To: Development Permit Panel
From: Brian J. Jackson, MCIP
Director of Development
Date: July 31, 2012
File: DP 12-598474
Re: **Application by Yamamoto Architecture Inc. for a Development Permit at 9100,
9120 and 9140 No. 3 Road**

Excerpt from the Minutes from
The Design Panel Meeting

No. DP 12-598474

JUL 31 2012
 PLAN #3C
 DP 12598474

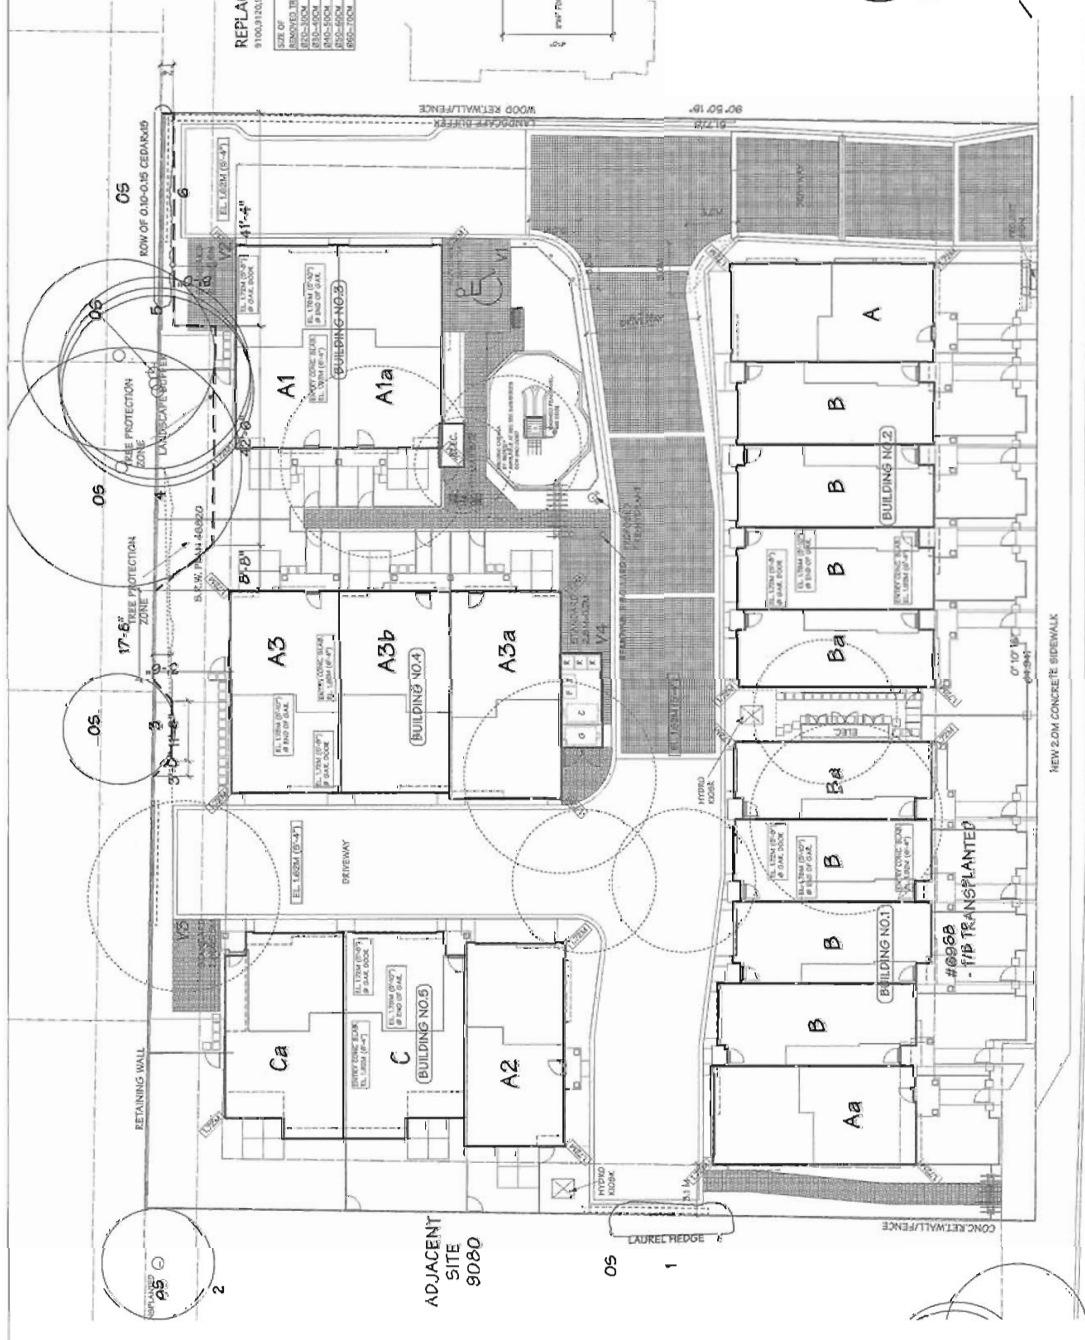
13. maintain the trees along the edge of the amenity area adjacent to the laneway as they do not cause visual obstruction; trees will provide protection to the amenity area;
